November 18, 2020

FAABostonWorkshops@esassoc.com
ATTN: Lorna Christian, Supervisory Senior Advisor, ANE

Environmental Science Associates
c/o Boston Logan RNAV (GPS) Approach EA
4200 West Cypress St
Suite 450
Tampa, FL 33607

The FAA’s proposed 4L RNAV procedure, applied to the closely spaced parallel Logan Runway 4L and 4R realities, is based on arbitrary and capricious assertions and assumptions, and is compounded by FAA’s material misstatements and omissions in its Draft EA and workshops.

Figure 41. Approach L_{MAX} Contour Widths for 7 Fleet Types Following Radar Median Approach Profiles

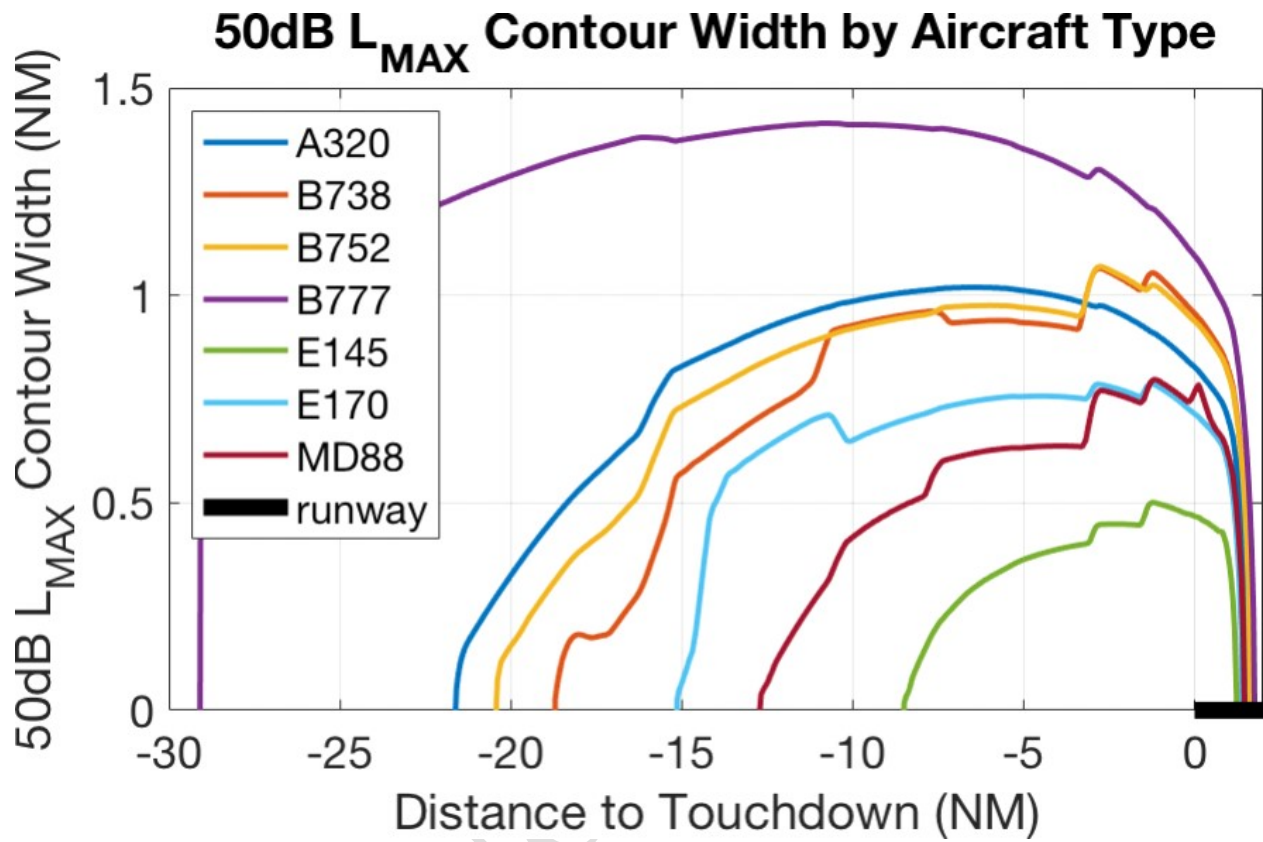
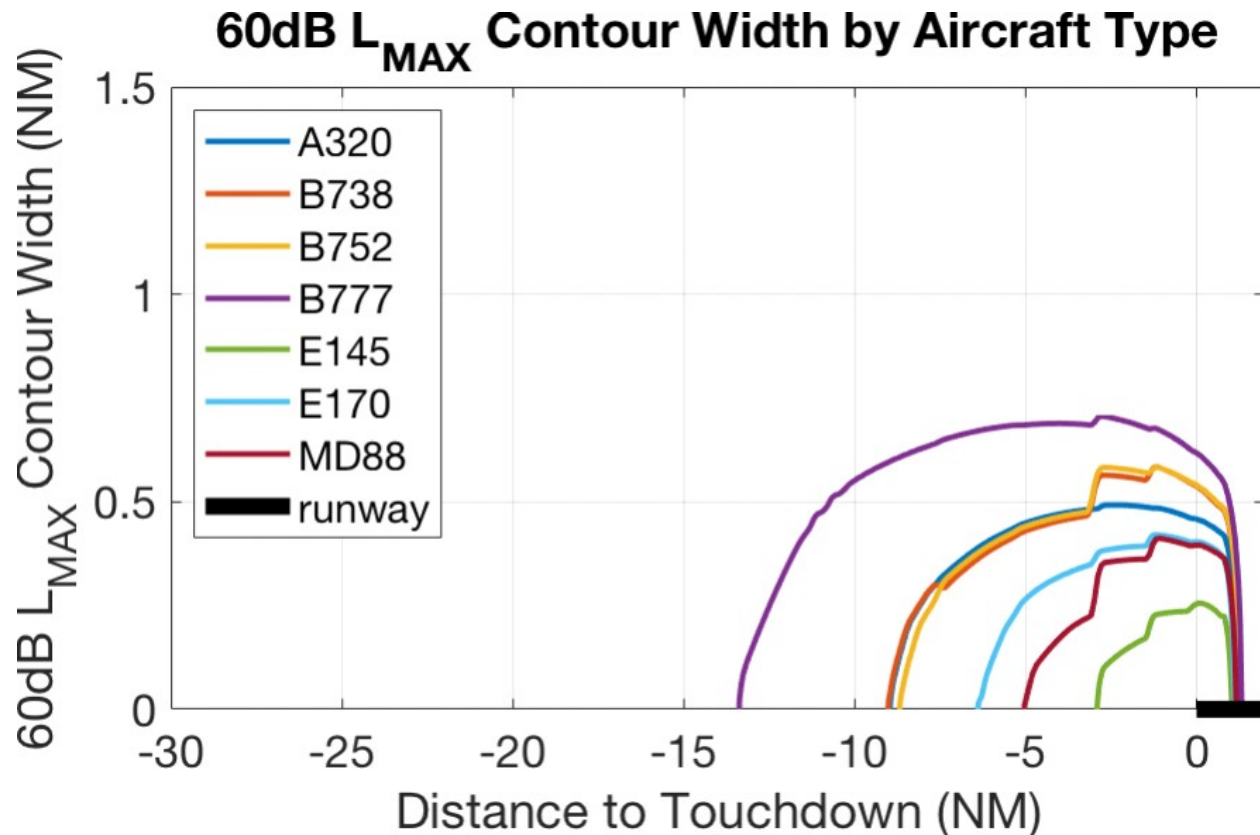
1. that planes proceeding along the 4L path create so-called **noise contours** that reach to the west and east side of each plane; and
2. by doing so, they extend 4L noise to the west of the path and 4R noise to its east; but also by extending 4L noise to the east toward the 4R path, and 4R noise to the west toward the 4L path create a **noise overlap** between the 4L and 4R paths increasing noise occurrence, intensity and duration in that between-CSPRs overflight area.

MIT identified aircraft noise contours as part of its work on the Massport-FAA study referred to earlier in these Comments. The following MIT diagram shows that from distances 15 nautical miles and less to touchdown many aircraft (each identified by type) generate noise contours of 50 and 60 decibels a mile wide (50 decibels) and half a mile wide (60 decibels). That contour width is wide enough to spread across the area between the proposed 4L RNAV and extant 4R RNAV flight paths as planes overfly residential Milton.

The foregoing paragraphs are prelude to this statement: the Draft EA's scope of analysis addresses none of the foregoing 4L/4R CSPR noise realities. Indeed, runway 4R is mentioned in the Draft EA at its Section 2.1.2 which only states its procedure elements, and in its Section 2.2.2.3 which exclusively addresses aircraft-to-aircraft wake turbulence issues created by 4L/4R closely spaced parallel flight tracks **without** any analyses of 4L/4R closely spaced parallel noise turbulence effects on residents.

Figure 2 – Contribution to the overall noise emission of a typical long-range jet airplane during the landing phase

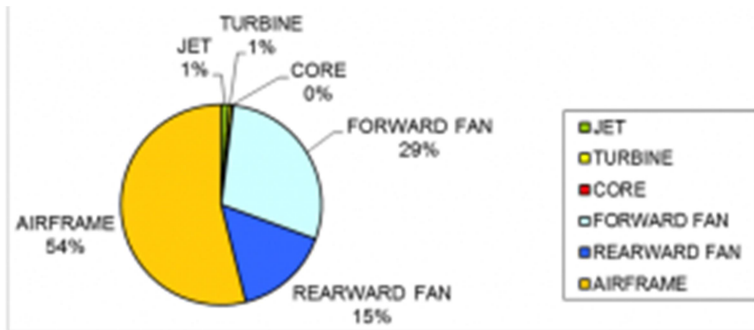
For a typical long-range airplane during the approach phase, around 54% of the noise stems from the airframe. Out of these 54%, 76% originate from the landing gear alone (see Figure 2 and Figure 3).

In total, the landing gear accounts for about 40% of the total noise emissions of a long-range airplane in approach conditions.
